Agenda Item # 5 BOA-002679-2023

1704 McGill Avenue

- Use, Parking Ratio, Access, Parking Surface, and Landscaping/Tree Planting Variances to allow four (4) dwelling units on a lot with a reduced parking ratio and sub-standard access with aggregate parking surface and reduced landscaping/tree plantings for an apartment complex in an R-1, Single-Family Residential Urban District.

APPLICATION NUMBER 6554 DATE November 6, 2023
APPLICANT Sire Investments, LLC (Michael Darrington, Agent)
REQUEST Use, Parking Ratio, Access, Parking Surface, and Landscaping/Tree Planting Variances

SITE PLAN

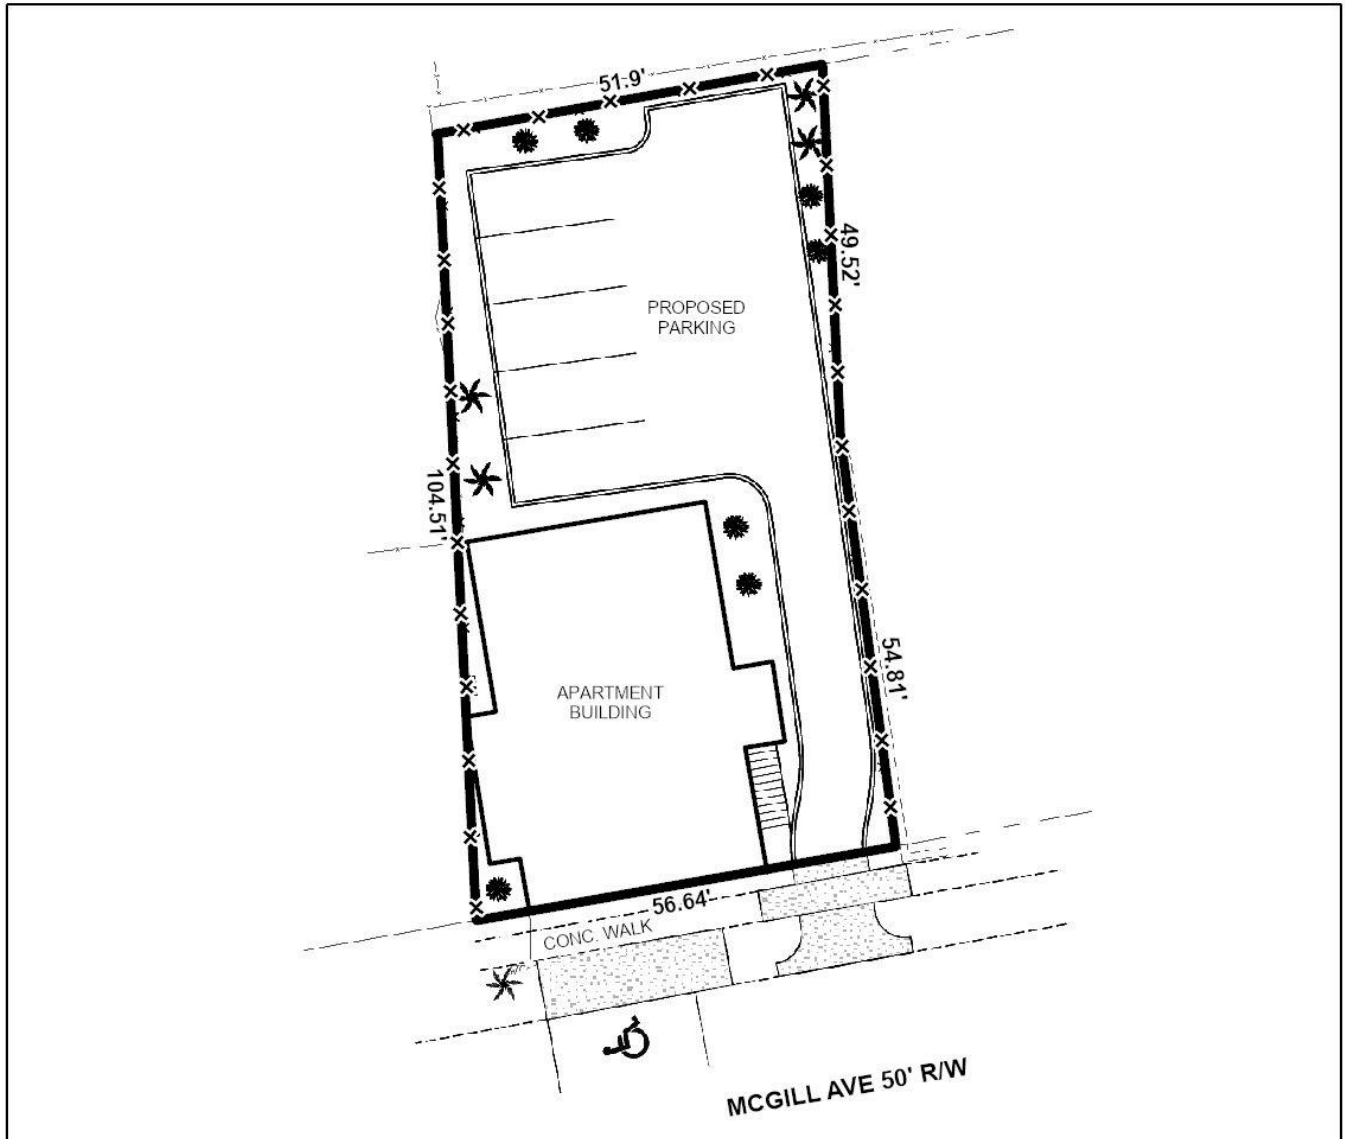
Providing the marked on-street parking does not allow for enough roadway width for two-way travel. Although on-street parking is allowed on residential streets it is not marked and not reserved for any particular property. Traffic Engineering does not approve marked on-street parking on residential streets.

The UDC requires all properties with two-way access to provide a driveway that is 24' wide. The site plan submitted illustrates a driveway that is 10' wide. Additionally, the UDC requires that all access aisles be surfaced with concrete, asphaltic concrete, asphalt, or concrete pavers. The proposed site plan illustrates a gravel access aisle.

Regarding the request for reduced parking, the UDC requires 1.5 parking spaces per dwelling unit be provided on-site for properties utilized as multi-family residential. If approved for four (4) dwelling units six (6) parking spaces would be necessary for compliance. The submitted site plan illustrates five (5) spaces with compliant dimensions.
